Wates Developments
Land adjacent to Deeping Road, Baston, Lincs

Formal Response to Consultee Comments

July 2026 (Revision A)

LAND ADJACENT TO DEEPING ROAD, BASTON, LINCOLNSHIRE
FORMAL RESPONSE TO CONSULTEE COMMENTS
JULY 2026 (REVISION A)

DRAWN BY	
NAME (PRINT)	DATE
CAB	07.07.26
CHECKED BY	
NAME (PRINT)	DATE
CJB	07.07.26
SCALE	1:500@A3
STATUS	PRELIMINARY
DRG. NO.	F20159/11
REV

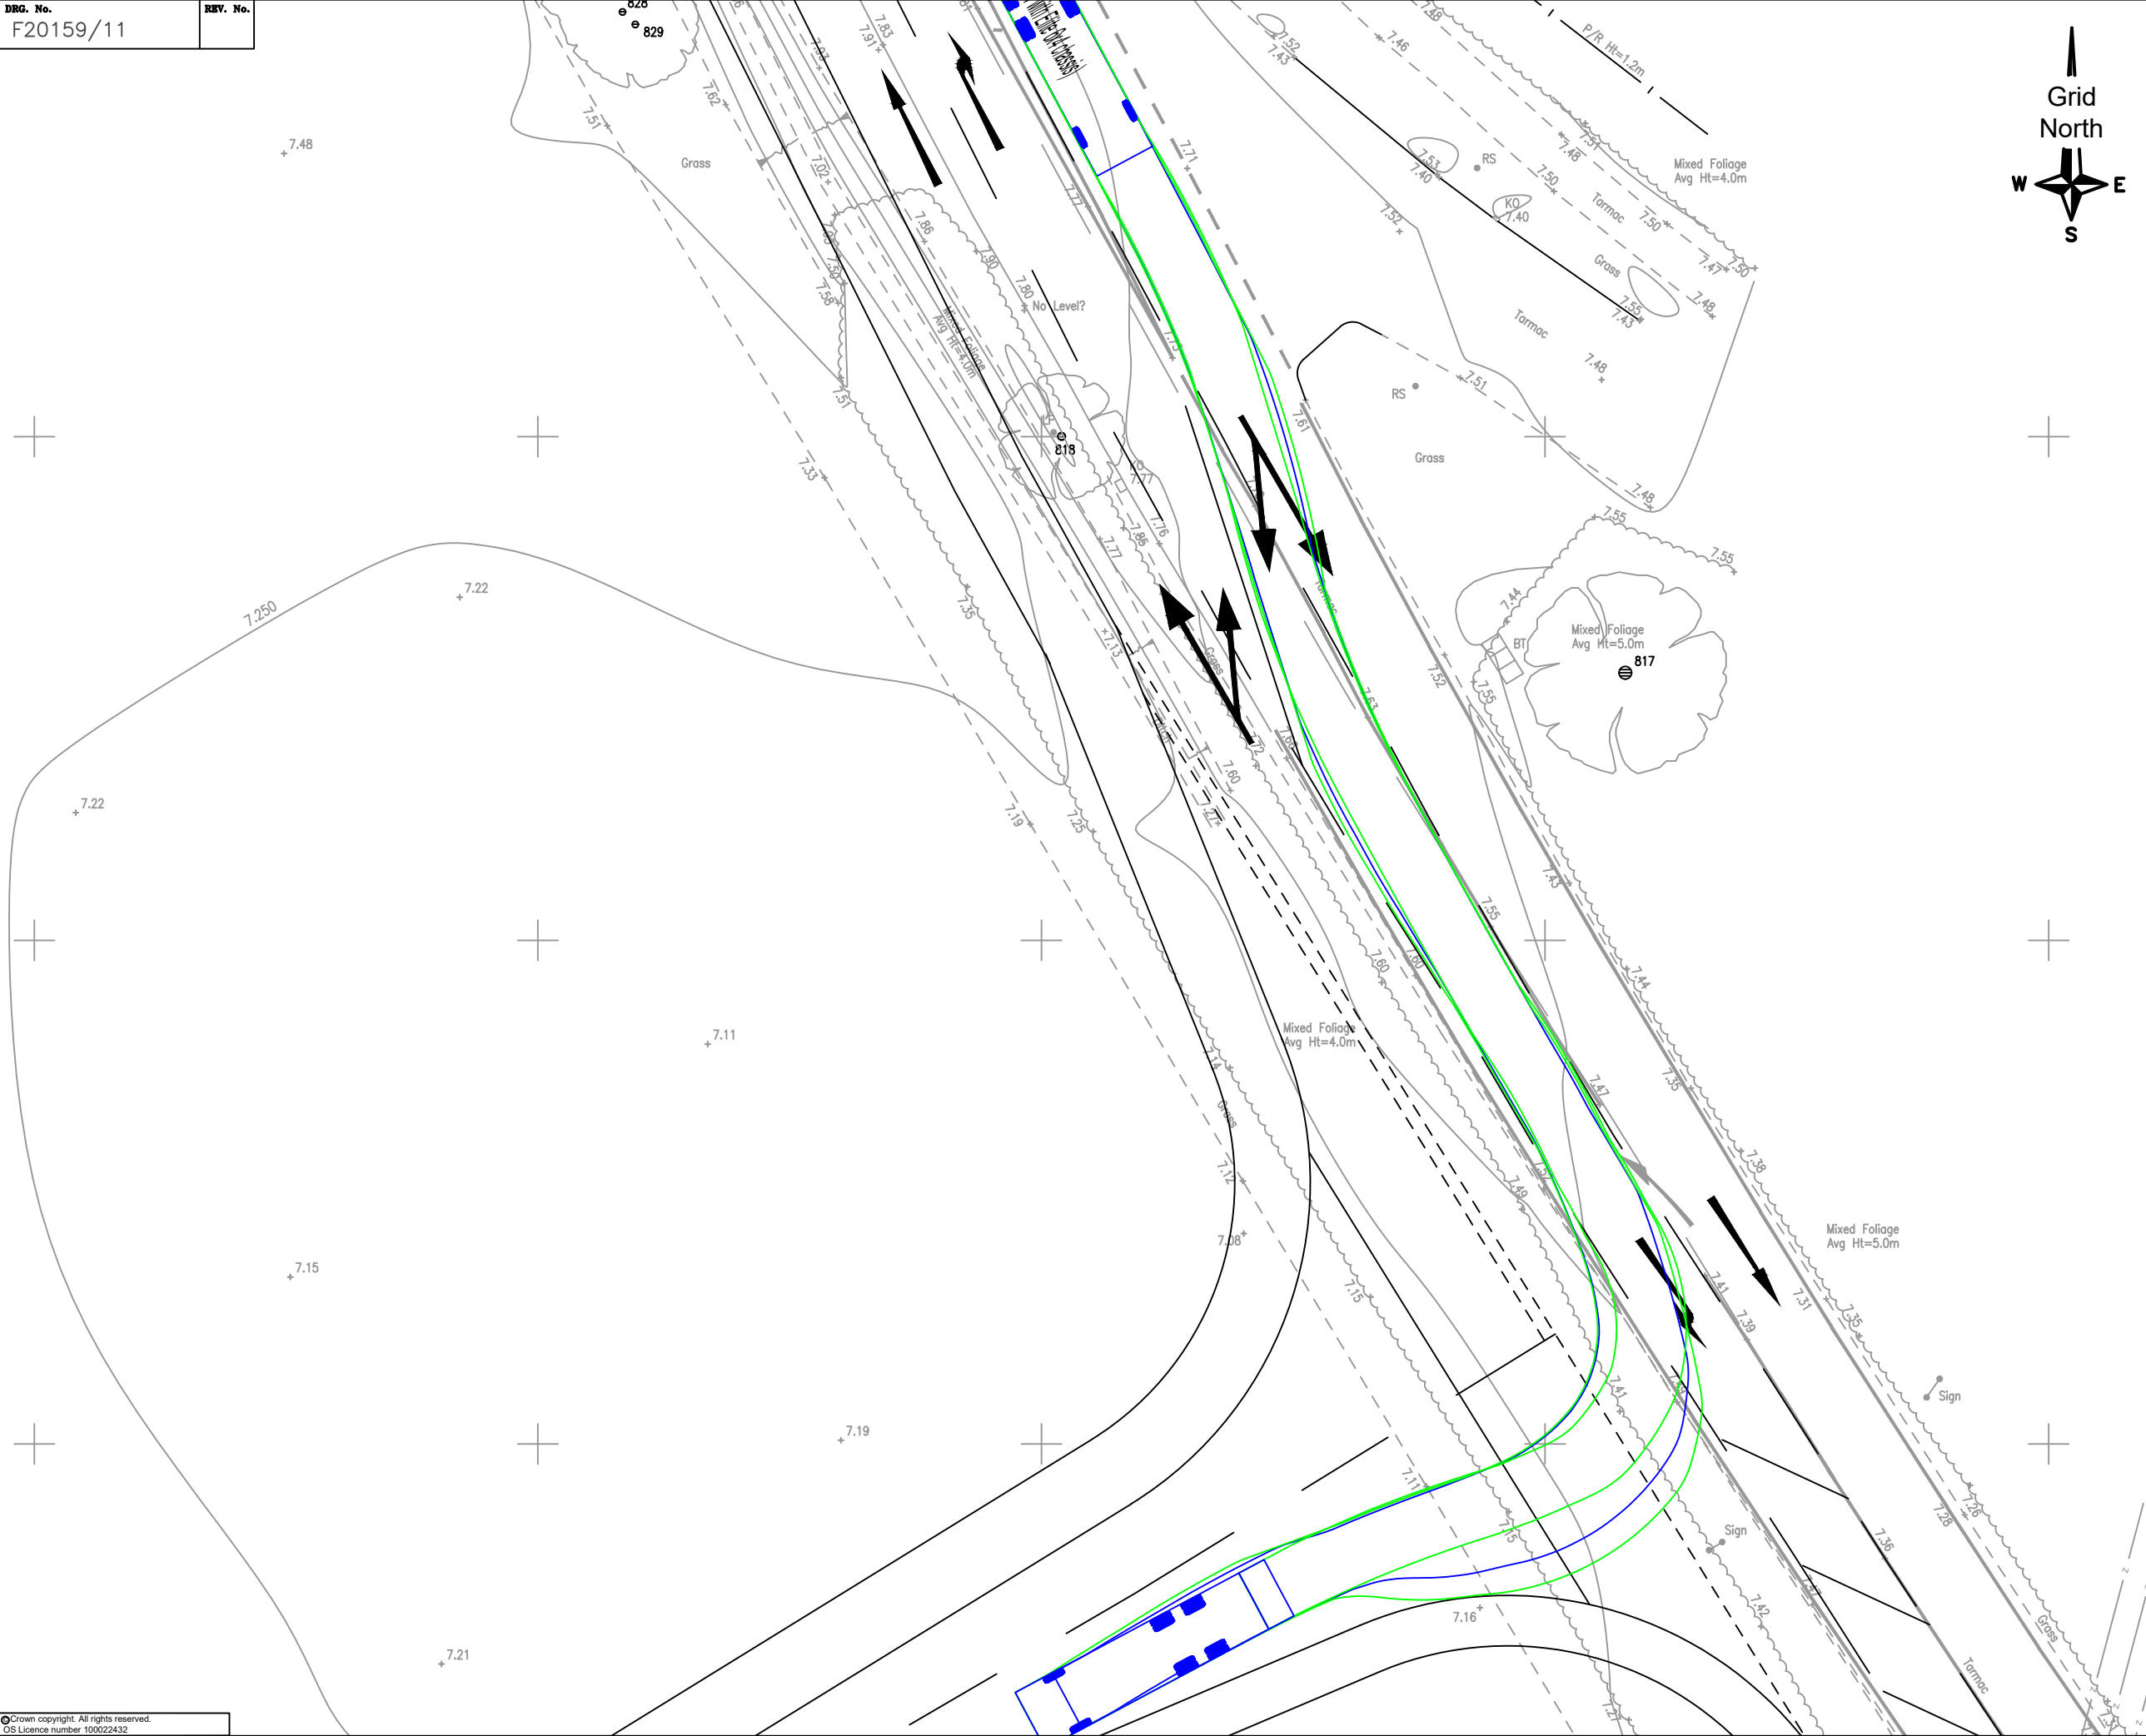
The principles of drainage for the highway improvements need to be detailed.	<i>Noted. Details to be provided at detailed design stage, secured by way of planning condition.</i>
Swept paths are required for the GIRTLS.	<i>Noted. Drawing Number F20159/11 now shows the tracking of a large refuse collection vehicle turning right into the site via the updated right turn lane arrangement.</i>
Pre-app discussions suggested improvements to King St Junction, but nothing has been detailed - improve connections to the PROW here.	<i>Section 9.4 of the Transport Assessment calculates how the proposed development would generate up to 6 hourly pedestrian movements, or 11 if bus movements are included too. These would primarily be associated with areas to the north and east of the site and are not expected to pass through the King Street / Greatford Road junction. Hence, in line with Paragraph 58 of the NPPF there are no proposals to deliver pedestrian infrastructure to extend the footway provision west of the proposed Greatford Road / Site Access junction.</i>

- **Drawing Number F20159/10** – shows tactile paving scheme at A15/Maltby Drive junction.
- **Drawing Number F20159/11** – shows large refuse collection vehicle turning into site at A15 via proposed right turn lane facility.

DRG. No.
F20159/14

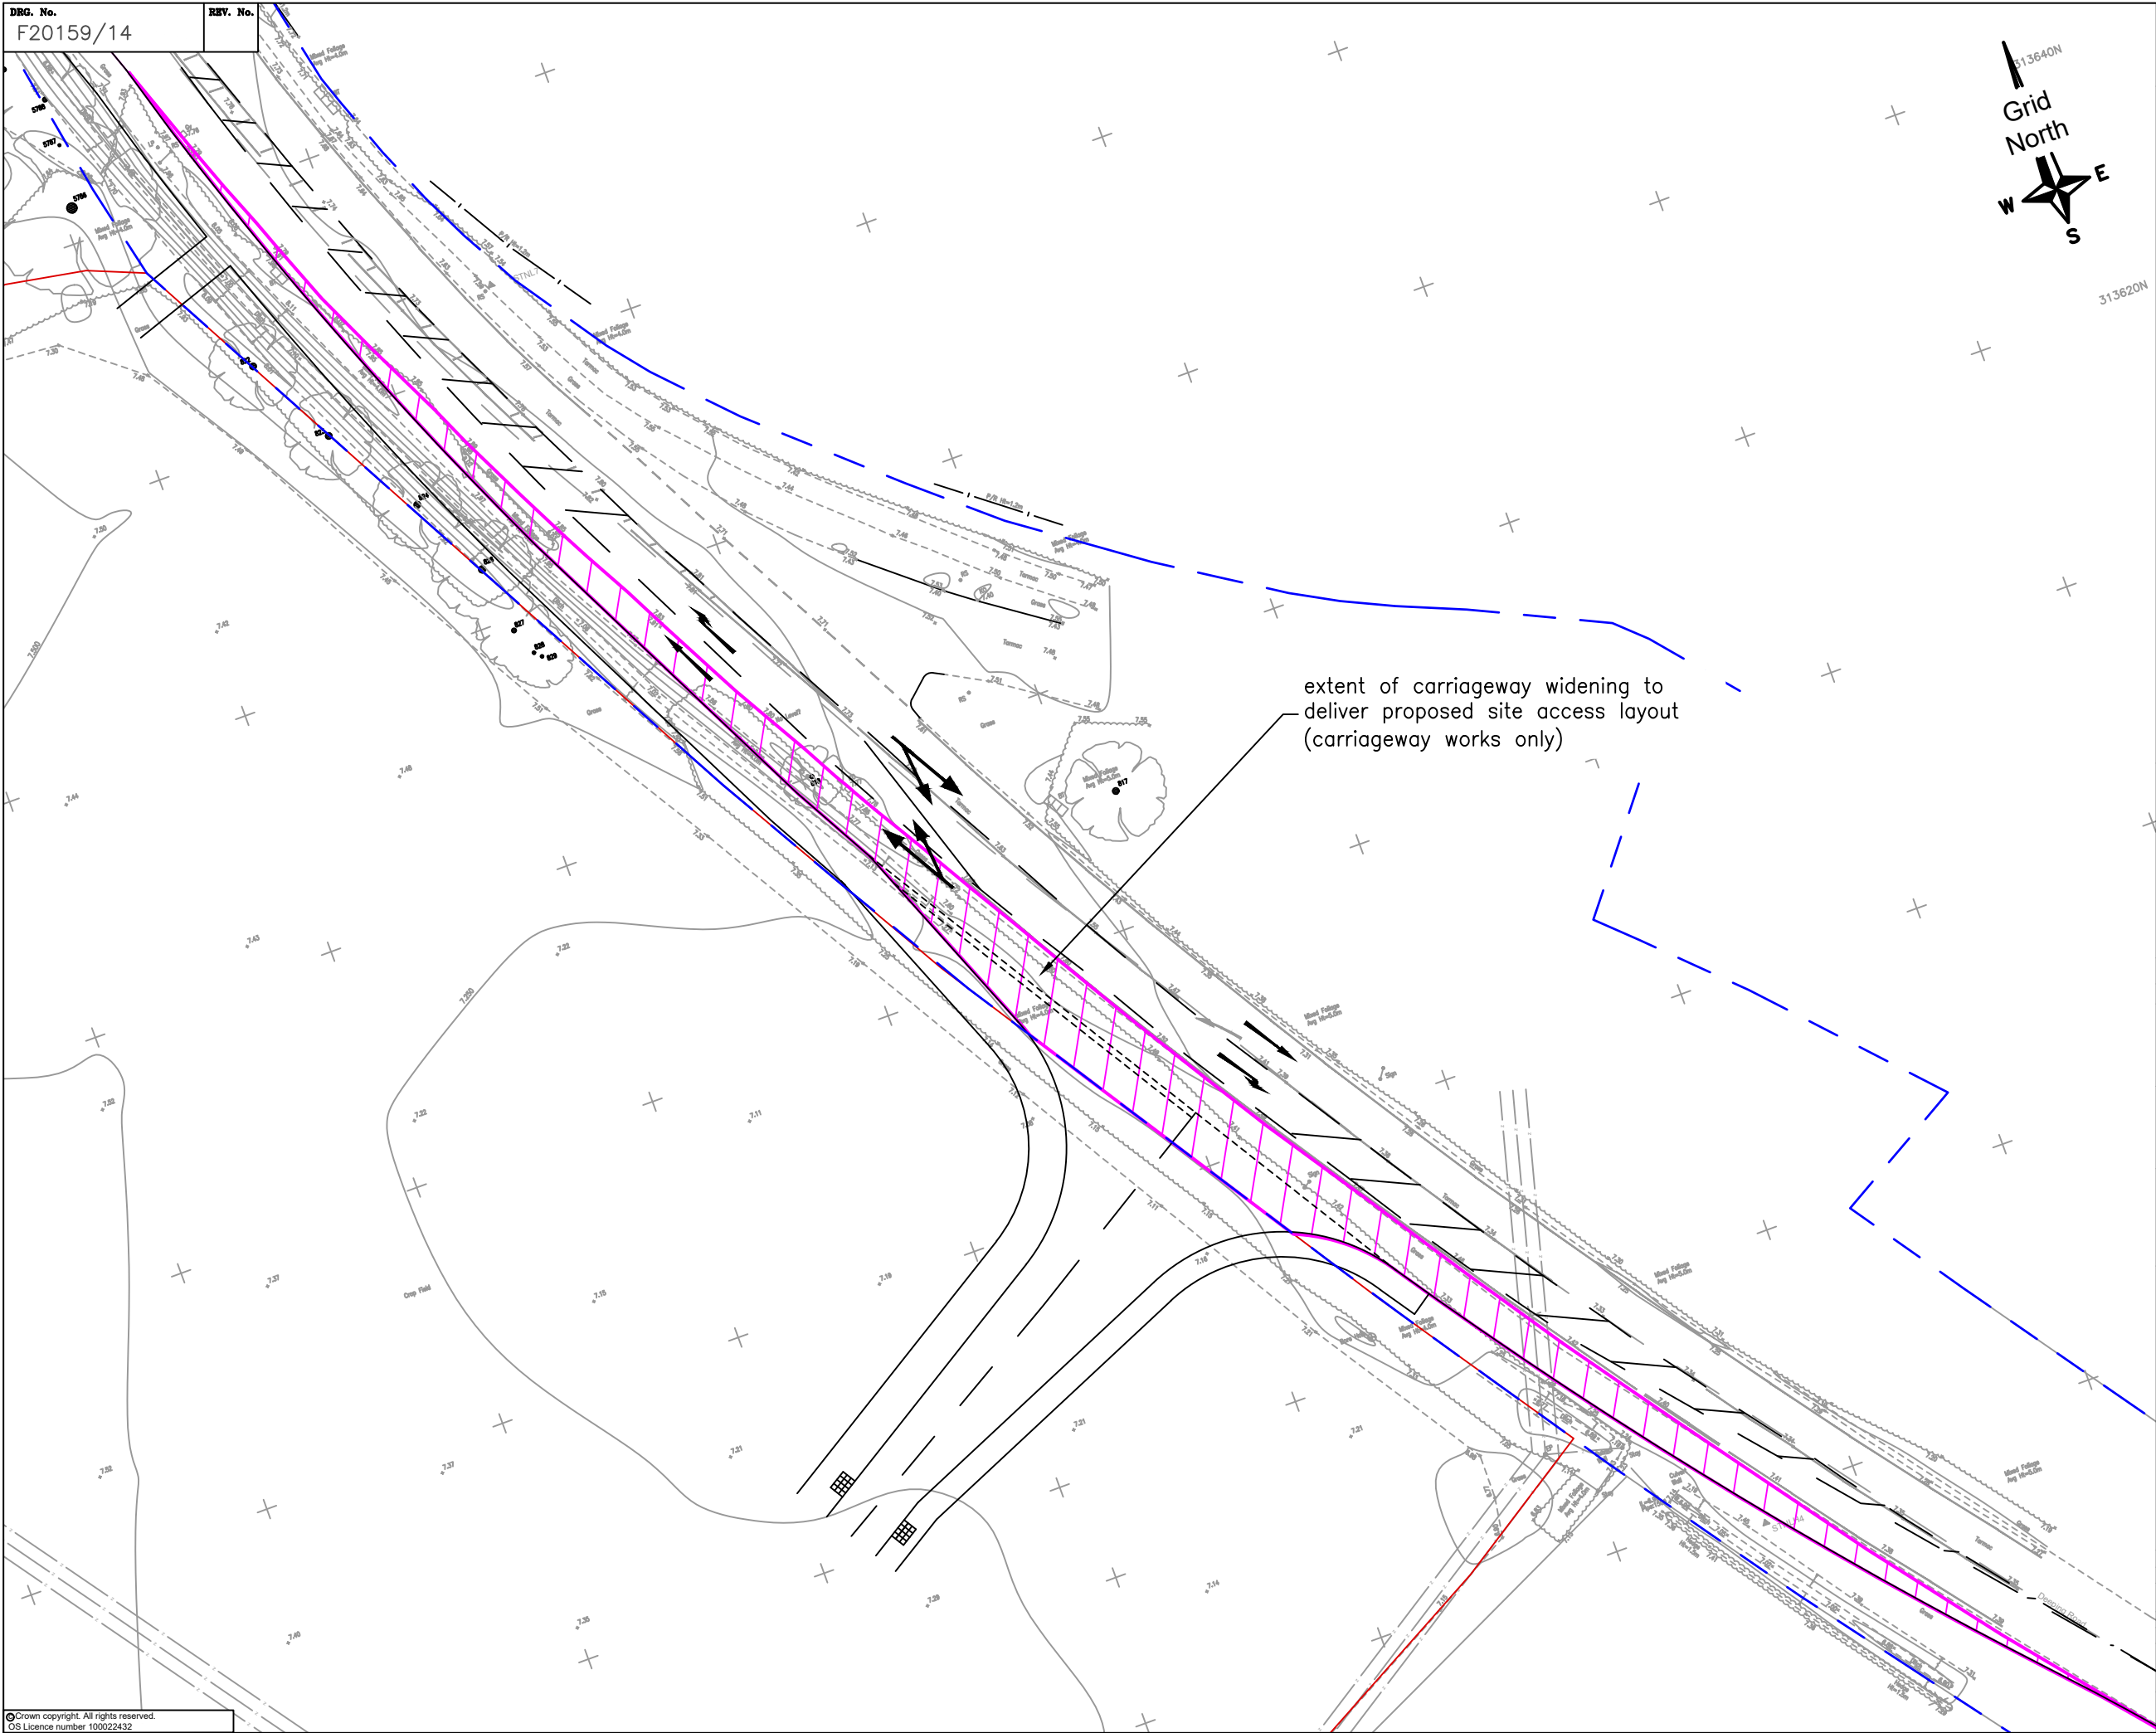
LCC Comment	BCL Response/Action
Footway/cycleway to terminate at Maltby Drive junction (A15).	<i>It will not be possible to extend the footway/cycleway up to Maltby Drive due to third party land constraints. However, Drawing Number F20159/06 Revision C now shows how a 1.8 metres wide link would extend north to connect with the existing facilities at the junction.</i>
The plan needs to show where the carriageway is being widened to accommodate the GIRTl.	<i>Noted. This is shown in the new Drawing Number F20159/14.</i>

- **Drawing Number F20159/14** – shows extent of carriageway widening required to deliver proposed right turn lane at A15.
